RESPONSE TO COMMENTS FOR 3RD ZN SUBMITTAL

RE: 17-ZN-2019, 10-AB-2019, 3-WM-2020
Solitude

Zoning District Map Amendment (17-ZN-2019):

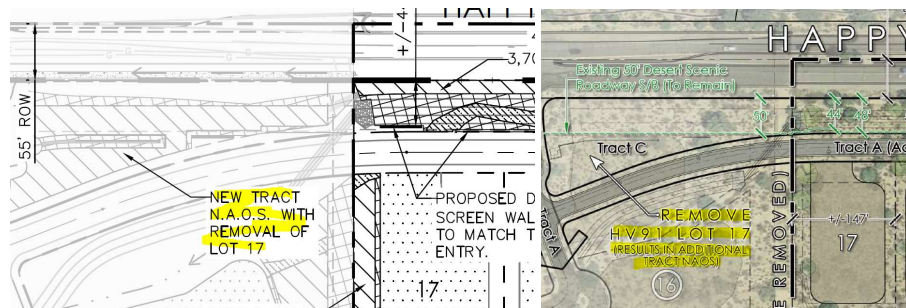
- Add lot 17 from the HV91 subdivision to the NAOS exhibit and covert lot 17 into Tract NAOS,

RESPONSE: Because this is not within the zoning boundary, we will provide this area (S.F) in the PP NAOS plan with detail. We added it graphically for the zoning albeit screened back with a note that it will be tract naos. We added this on the site plan as well.

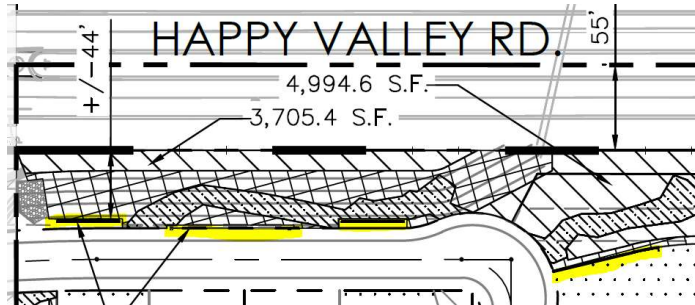
- Provide five (5) feet of revegetated NAOS along both sides of the theme wall located on-lot 17 of HV91.

RESPONSE: The NAOS boundaries have been reworked around the theme walls. Also, 5' or more of reveg NAOS surrounds those walls.

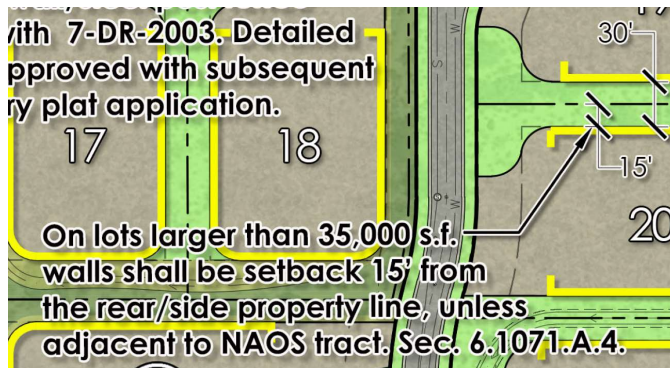
- Pursuant to ZO Section 6.1071.A.4., on lots larger than 35,000 square feet, individual or site walls shall be setback a minimum of fifteen (15) feet from a side or rear property line unless the parcel is adjacent to a NAOS Tract. On a revised wall exhibit, please identify and dimension the required wall setback on lots greater than 35,000 square feet that are not adjacent to NAOS.

RESPONSE: This is understood and is accommodated. A specific note has been added to the wall plan.

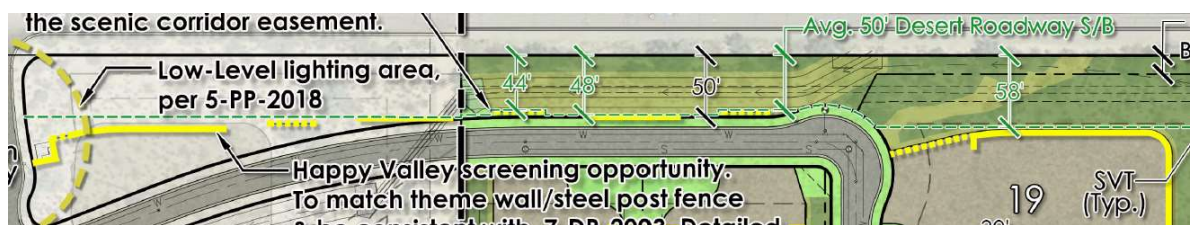
- On a revised wall plan, please conform to the Desert Buffer Setback requirements by eliminating walls within the corridor, shift walls south to maximize buffer area and consider the steel post fence along the corridor maintain an open corridor (1-GP-2004).

RESPONSE: Walls have been pulled back and out of the desert buffer setback to maintain an area consistent with the allowed dimensions (avg. 50') of the required buffer. Specific wall details will be coordinated through the development review (PP) case.
